Product Change Notification: PCN-22-129219

2.5mm SIGNAL DBL-LOCK 4P PLUG HSG.

External latch appearance

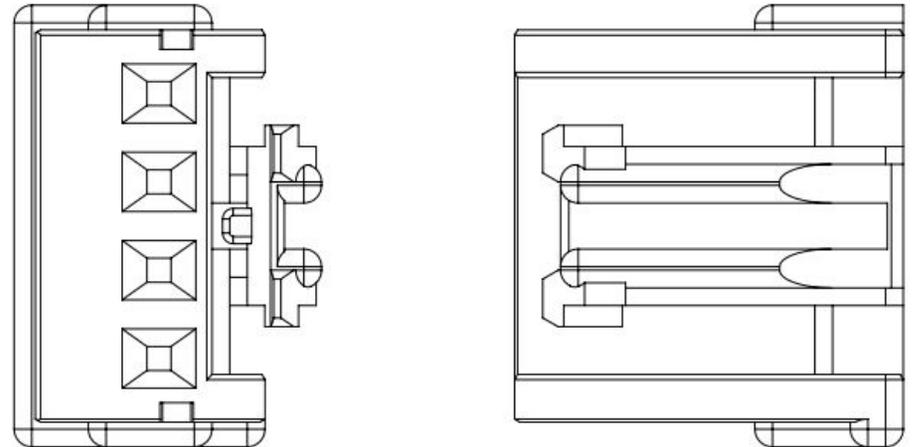
External latch feature upgrade per customer request-To further enhance the external latch locking force although current performance meet 108spec. ,please be aware of an upcoming feature change to the listed part numbers.
